Memorandum

To: Ric Weinschenk
CC:
From: Mike Nugent/Manager of Inspection Services
Date: 08/27/2002
Re: 548 Island Ave.

I have done a partial review of the building plans and need the following:

RE: STEVENSON GLAZING

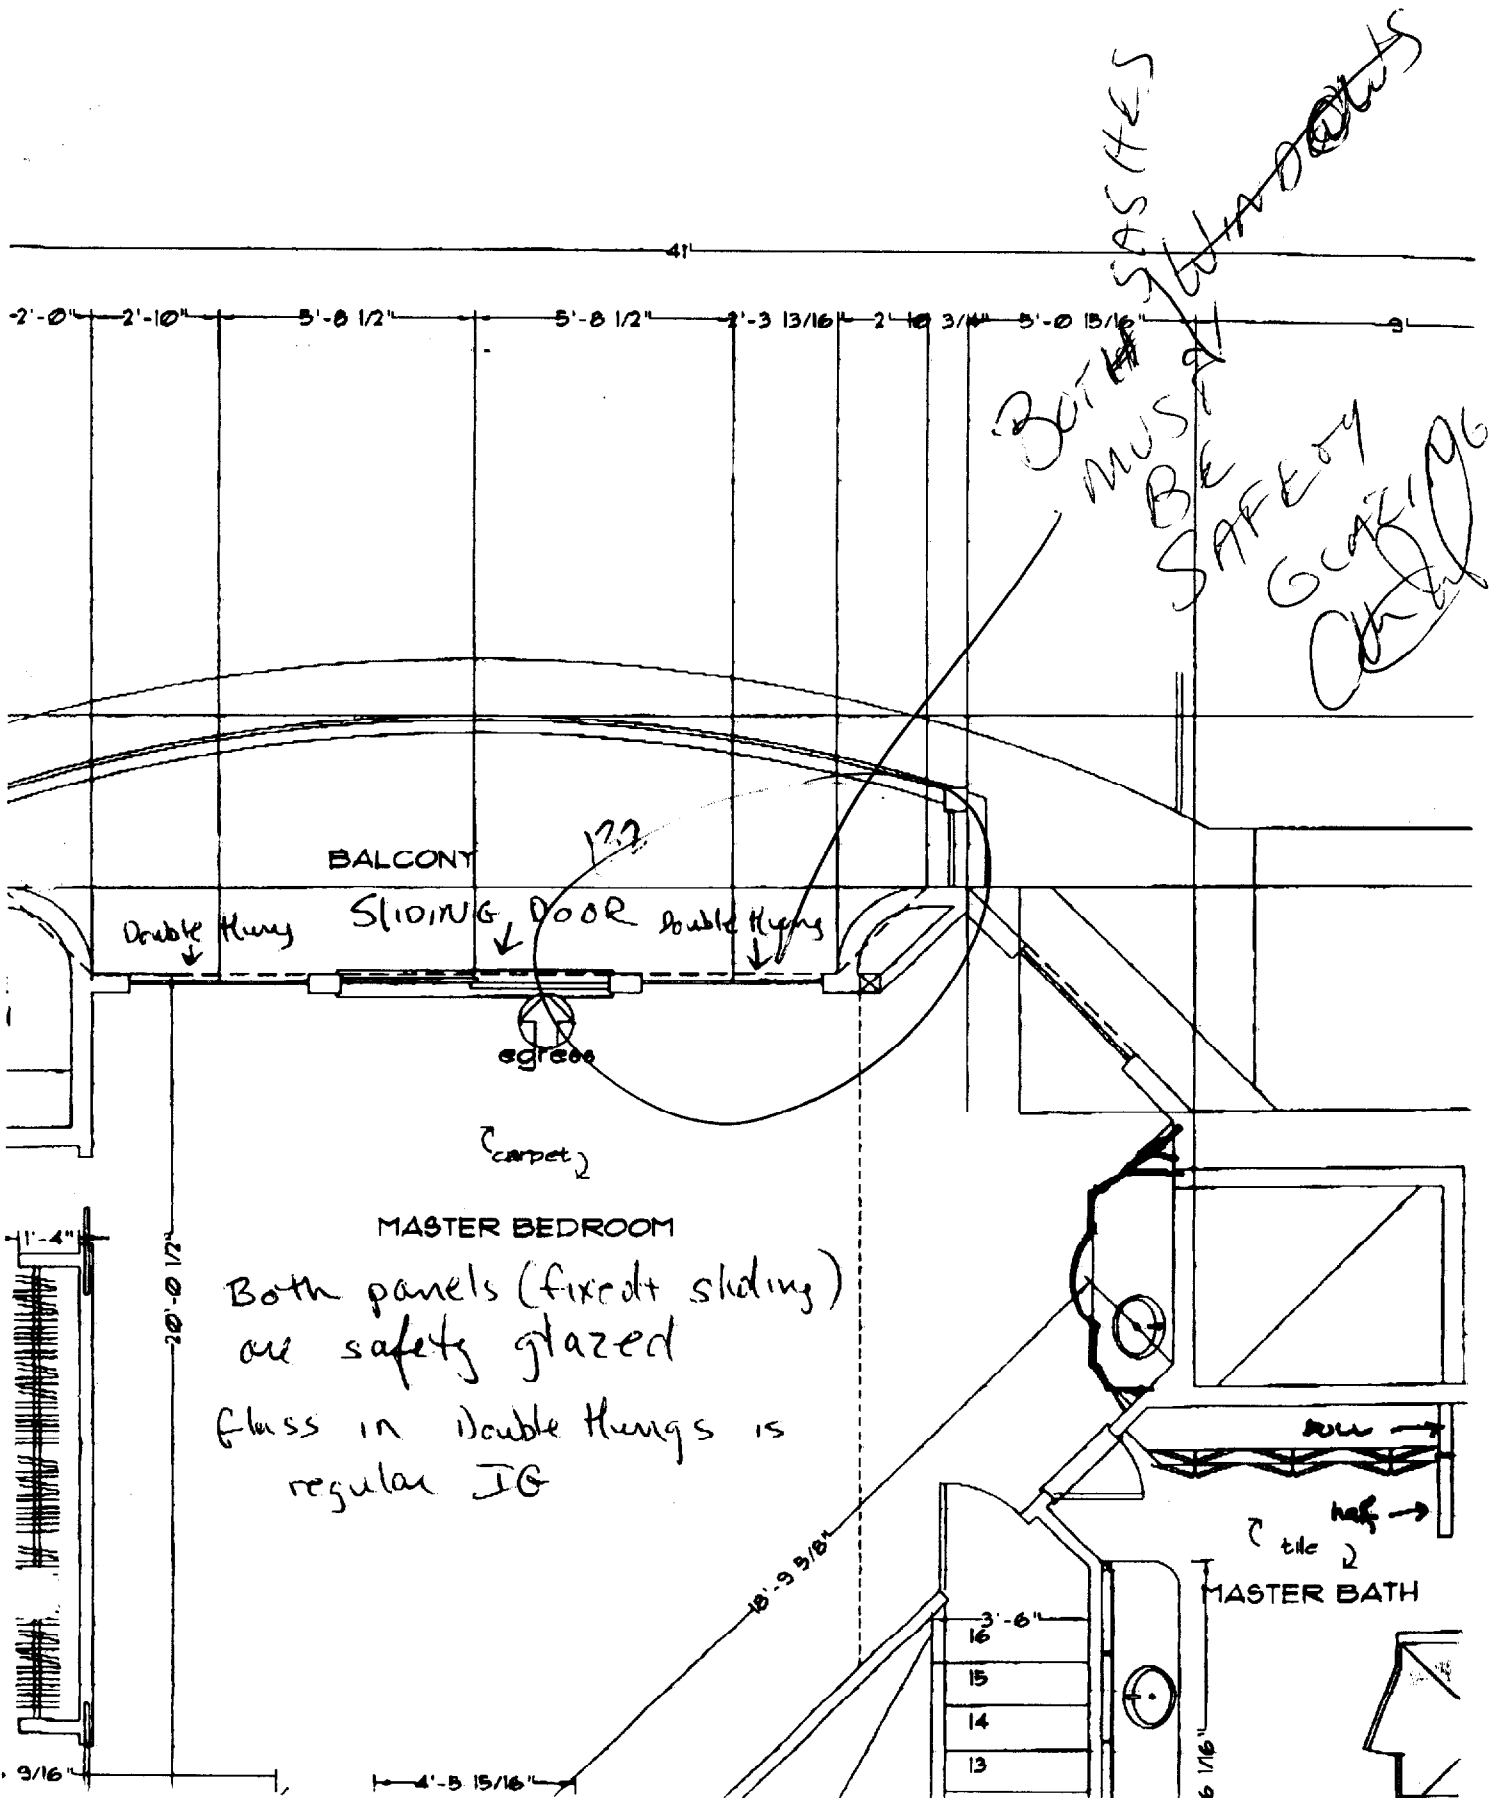
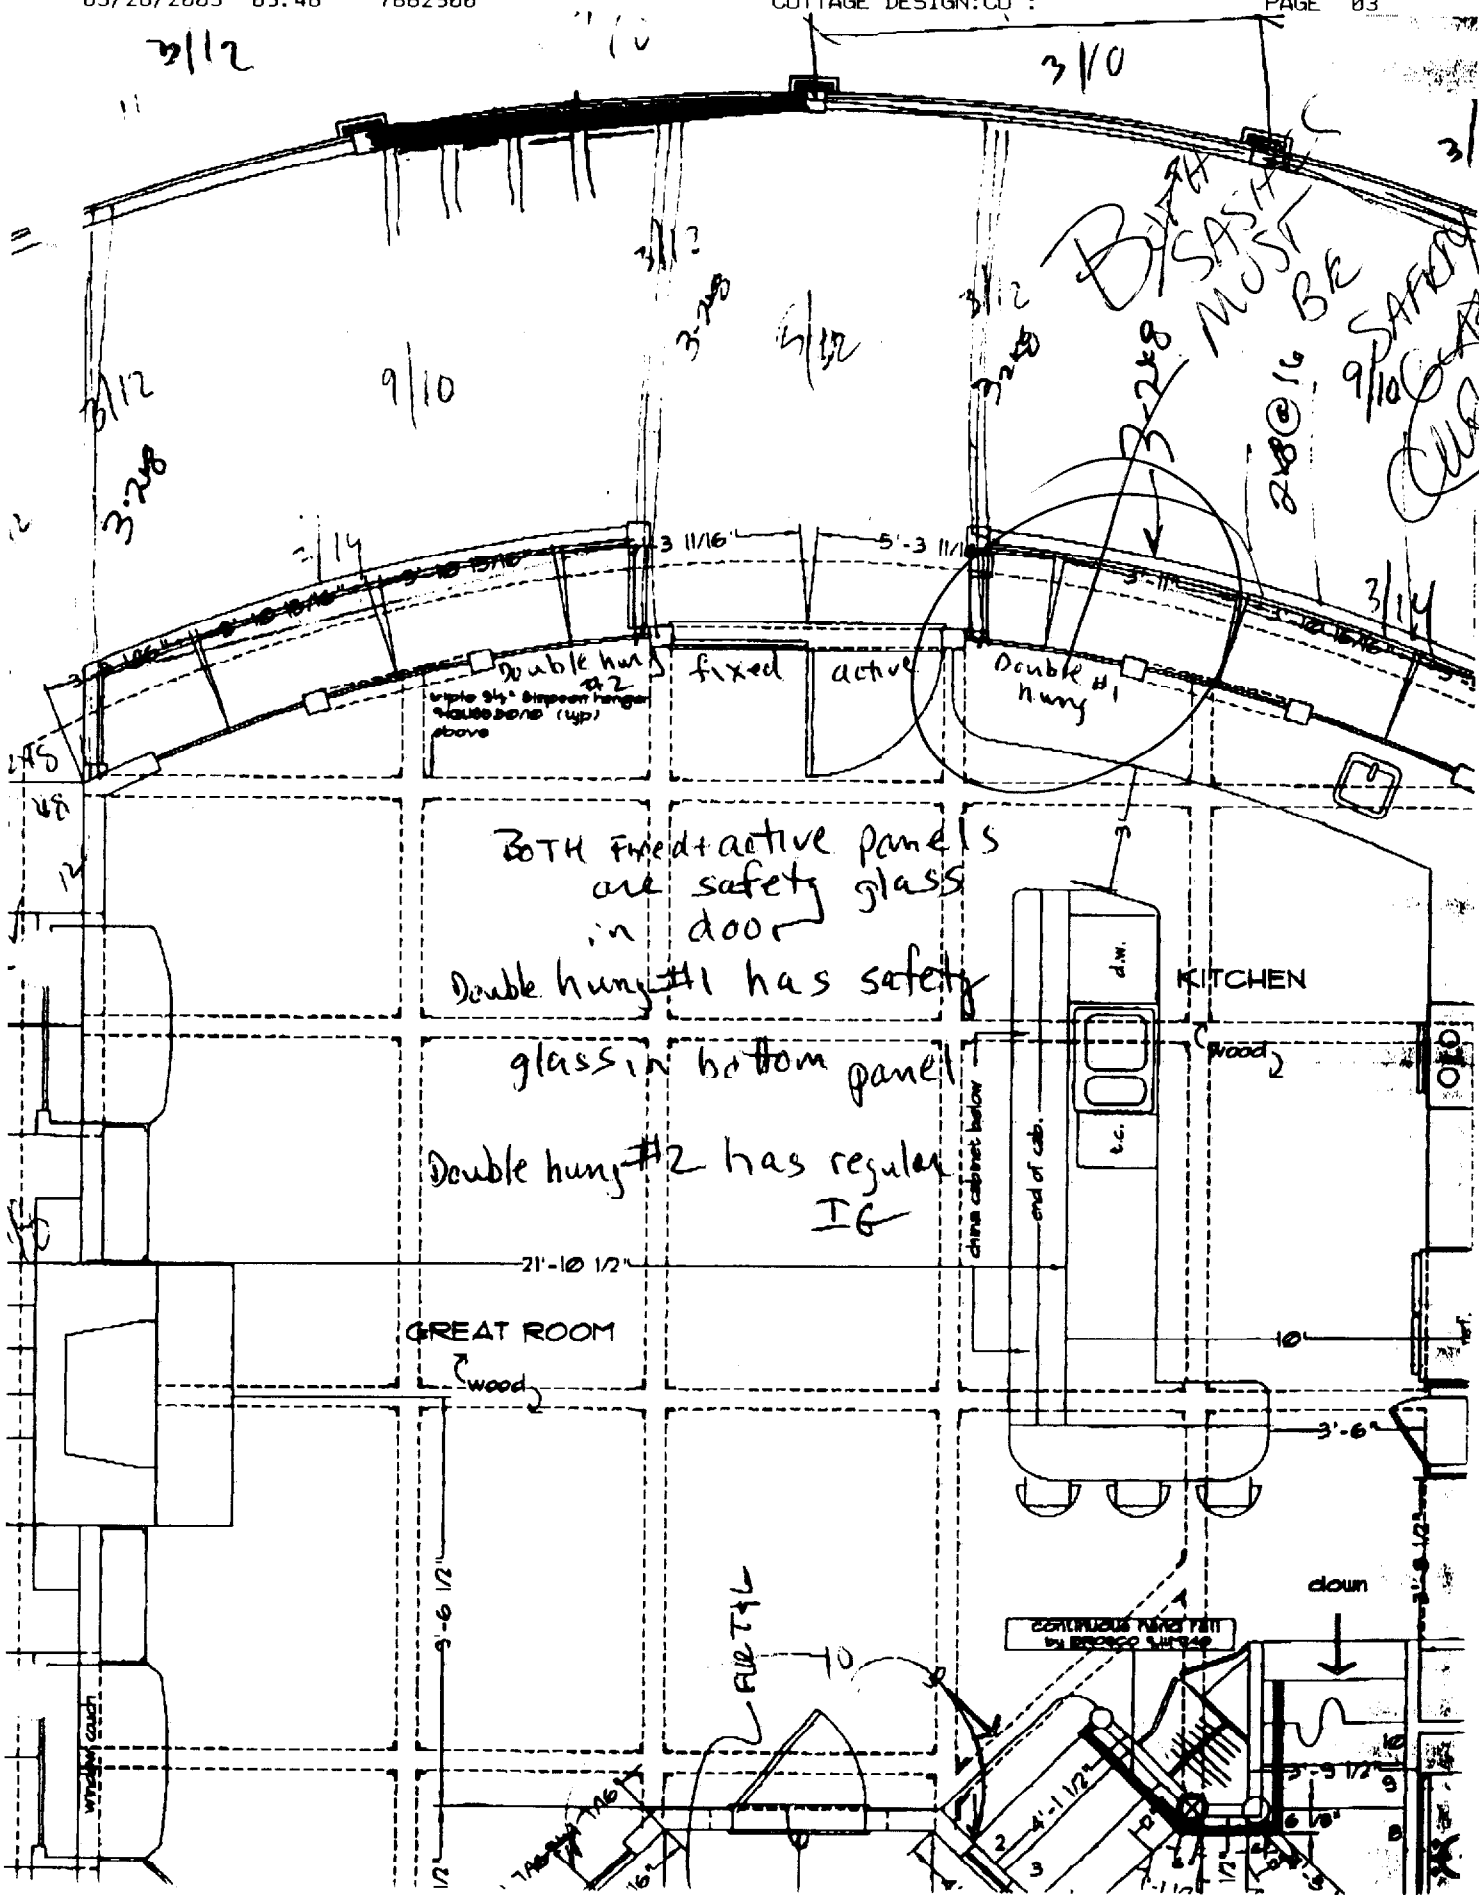
Mike - Sorry for being confusing.
With the attached plan I have illustrated what we spoke about via phone. I was not sure about windows adjacent to sliding doors (non-swinging) + fixed panels of doors (non-swinging). I believe we agreed they did not have to be safety glazed. Only the glazing by the swinging door up to 60". I hope this is more clear.

BOTH fixed + active panels are safety glass in door
Double hung #1 has safety glass in bottom panel
Double hung #2 has regular IG
